VKM 16040 - VKMA 06040

Technical Bulletin - May 2009

FORD, VOLVO

Tensioner design evolution

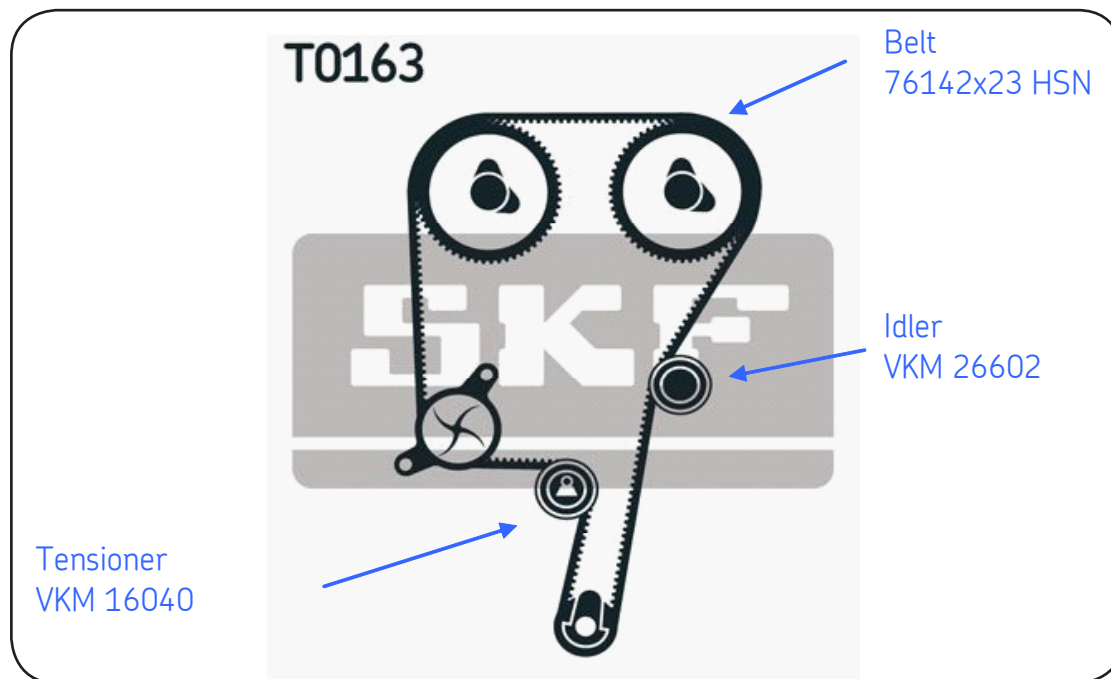
In accordance with the OE design evolutions, SKF only propose the latest tensioner evolution - VKM 16040. The previous version (without pin) can be replaced by this part without any modification to the timing system or any other components.

Previous design (without pin)

Latest design (with pin)
